RS-13-207

LaSalle County Station, Units 1 and 2  
Facility Operating License Nos. NPF-11 and NPF-18  
NRC Docket Nos. 50-373 and 50-374

**Subject:** License Amendment Request to Revise Loss of Voltage Relay Settings for 4.16 kV ESF Buses

**Design Analysis L-002588, Revision 1E, "Loss of Voltage Relay Setpoint for 4.16 kV  
Buses 141Y, 142Y, 143, 241Y, 242Y, 243 – Undervoltage Function"**

**Attachment F: Acceptance Regions for Calibration Checkpoints for ITE-27 Relays Page F2 of F2**

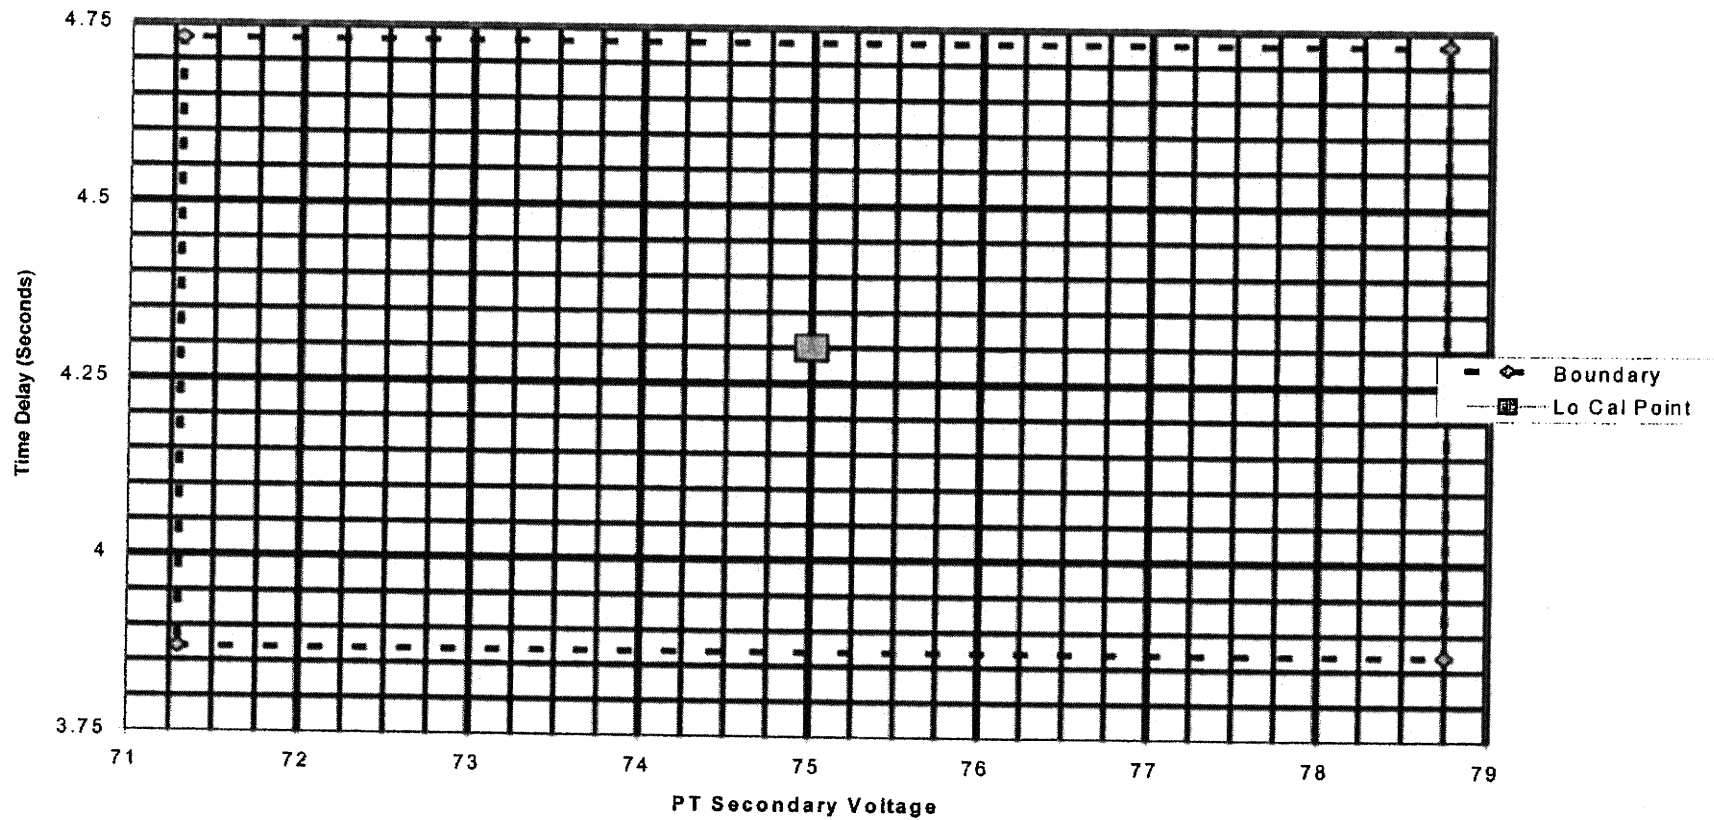
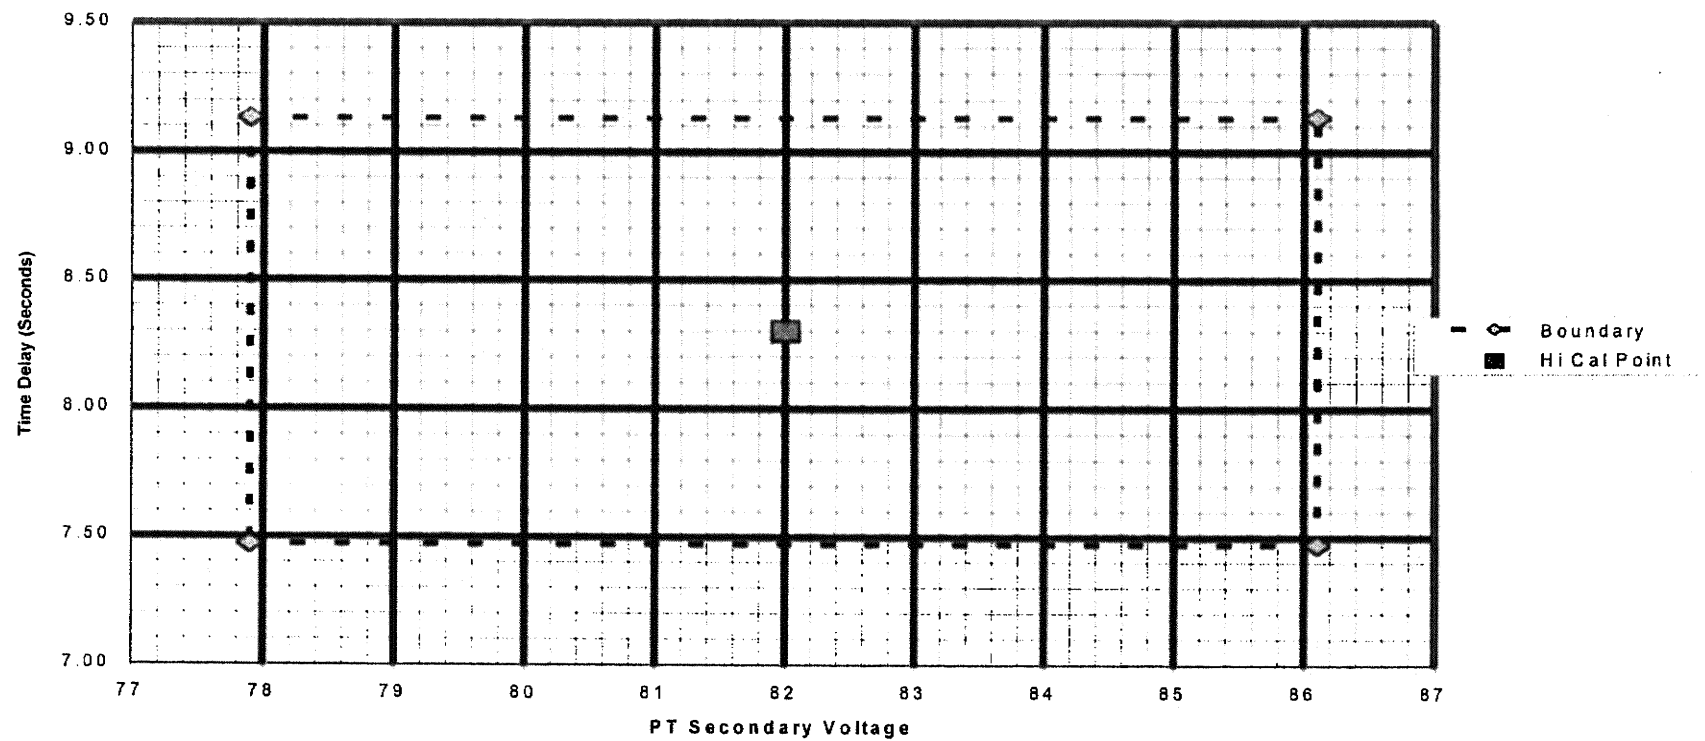
The purpose of this revision to the calculation is to revise the computed values to provide a set of acceptance criteria such that the calibration of the ITE-27 type inverse time low voltage trip relay will better coordinate with the requirements of the design and still meet Technical Specification requirements.

4.8 Calibration checkpoints will be at or near the high and low technical specification range when setting tolerance is included. From Design Input 4.2 the setting tolerance for voltage is ± 5.0 %. The low checkpoint is approximately 75 Volts computed from the value in section 6.4 of 71.37 volts adjusted up by 5% tolerance. The high checkpoint is approximately 82 volts computed from the value in section 6.4 of 86.49 V when adjusted down by 5% tolerance. These two voltages, 75 Volts and 82 Volts, will be used for calibration checkpoints. These adjusted calibration points will provide some additional conservatism in that the inverse voltage curve that will fit them will meet tighter constraints.

**Replace Attachment F with the contents of Attachment B of this minor revision.**
